TECHNICAL INSTRUCTION

TI 033

NETWORK RAIL - SIGNAL ENGINEERING

DOUBLE CUTTING OF BACK CONTACTS IN SAFETY CRITICAL CIRCUITS

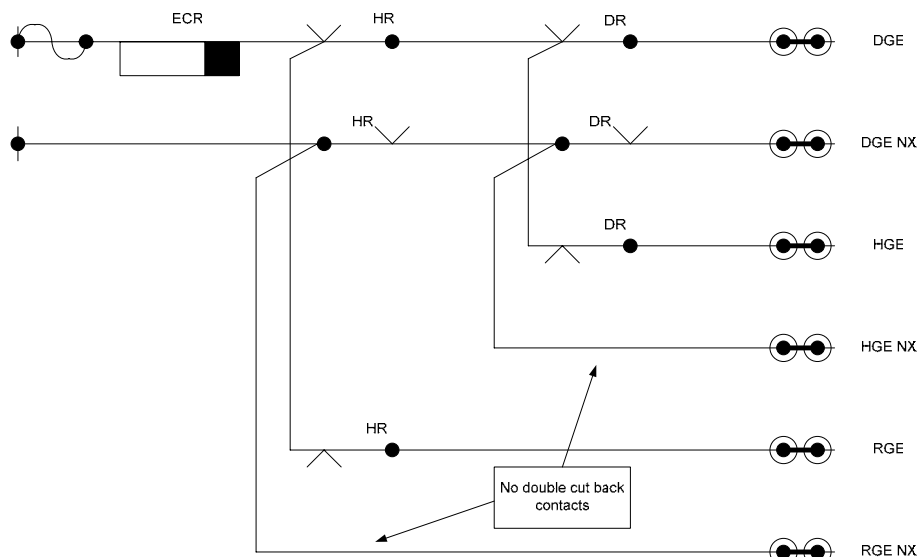
The back contacts of an HR/GR relay used to illuminate the red aspect or of a DR relay used to illuminate the first yellow aspect or the top yellow of a signal capable of displaying a preliminary caution should not be double cut.

Pending an amendment to the typical circuits for LED signals, back contacts in the NX110 feed to the signal head should be omitted.
